FORM APPROVED  
OMB NO. 1004-0137  
Expires: January 31, 2018**SUNDRY NOTICES AND REPORTS ON WELLS**  
*Do not use this form for proposals to drill or to re-enter an abandoned well. Use form 3160-3 (APD) for such proposals.*5. Lease Serial No.  
NMLC064200

☐ Oil Well ☒ Gas Well ☐ Other8. Well Name and No.  
PENNZOIL FED 1

**Permanent Abandonment of Federal Wells  
Conditions of Approval**

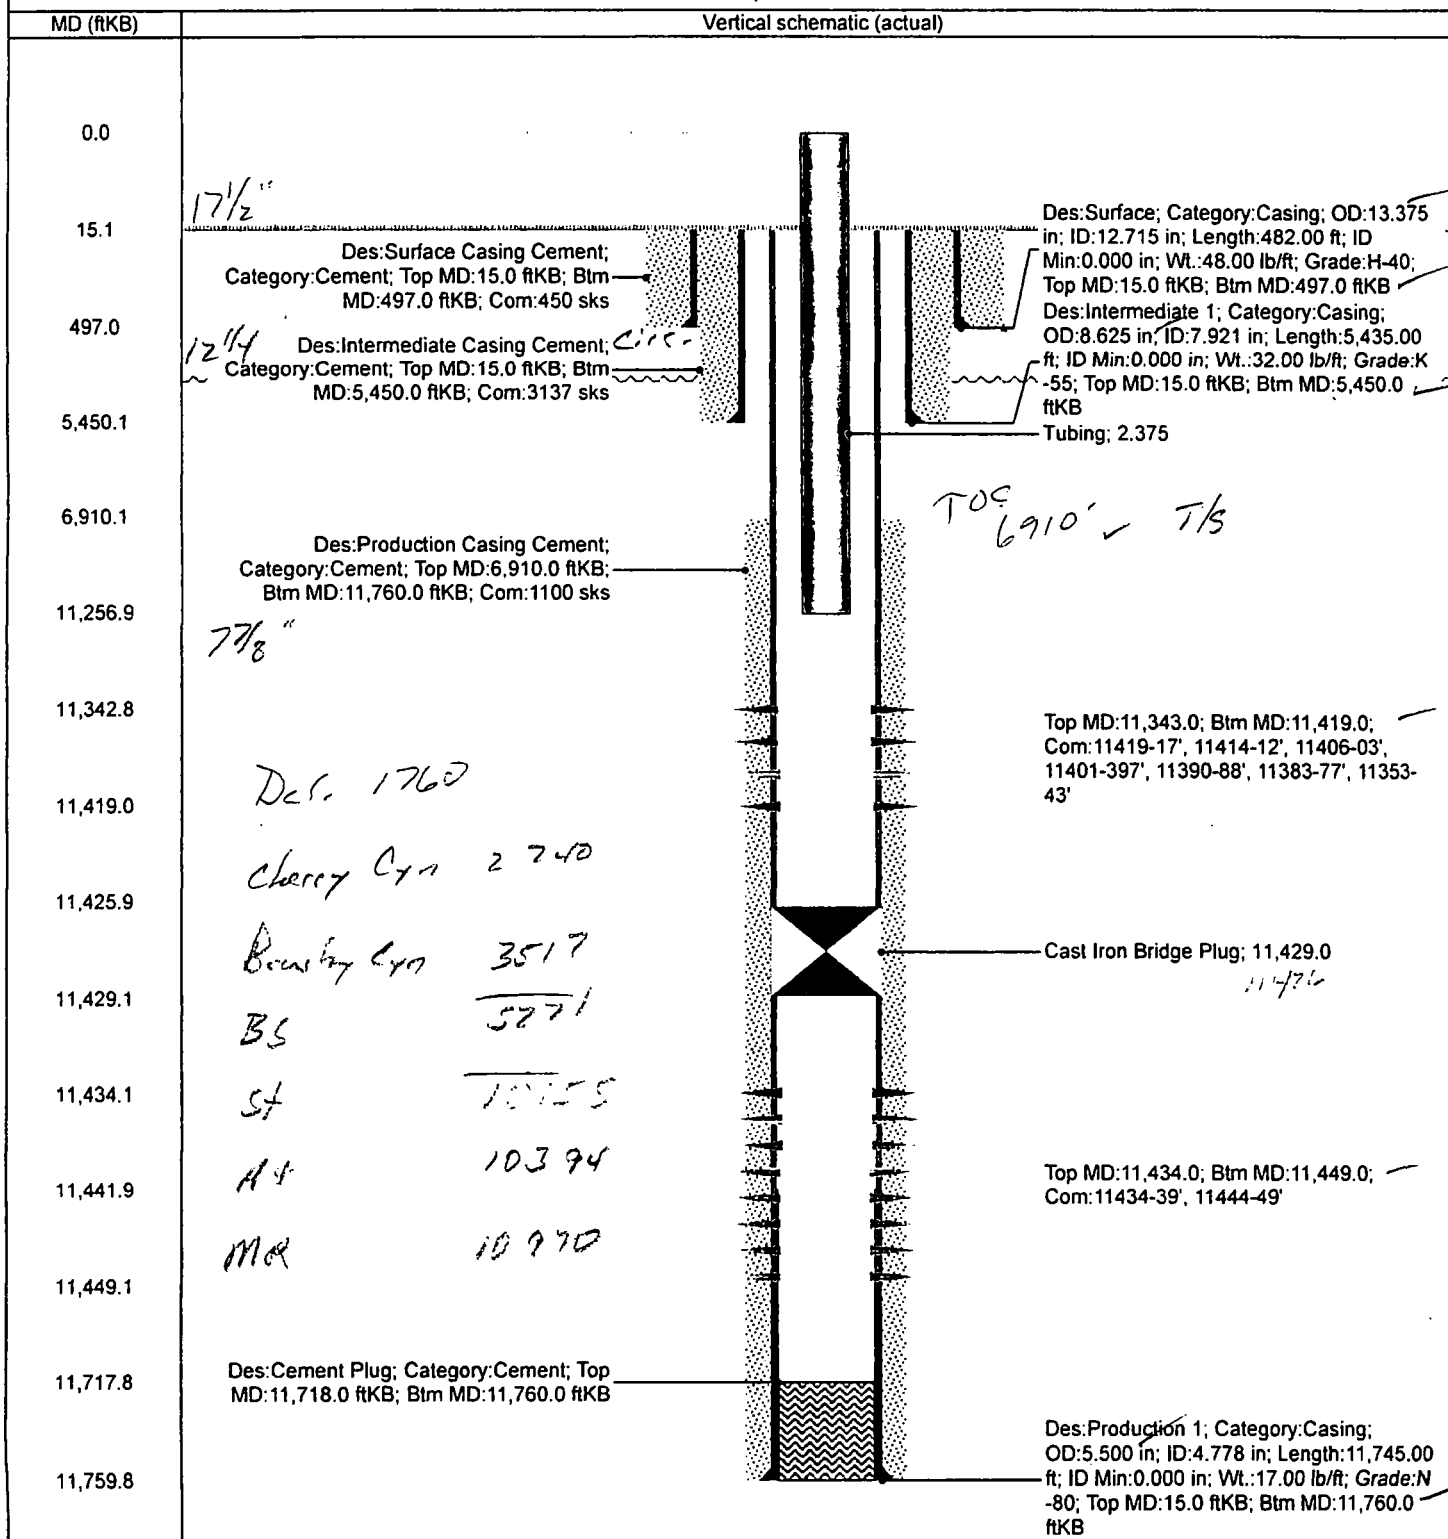
1) 5 1/2 CIBP @ 11,250' w/35sx cmt.

2) 80sx 5,500' - 5,221' P.S. Tag.

3) 40sx 1,810' - 1,710' P.S. Tag. 120' min.

4) 75sx 547' - 447' P.S. Tag.

5) 75sx 100' - Surf. P.S. Verify cmt to surf.

SEE ATTACHED FOR  
CONDITIONS OF APPROVALGC 12-3-18  
Accepted for record - NMOC
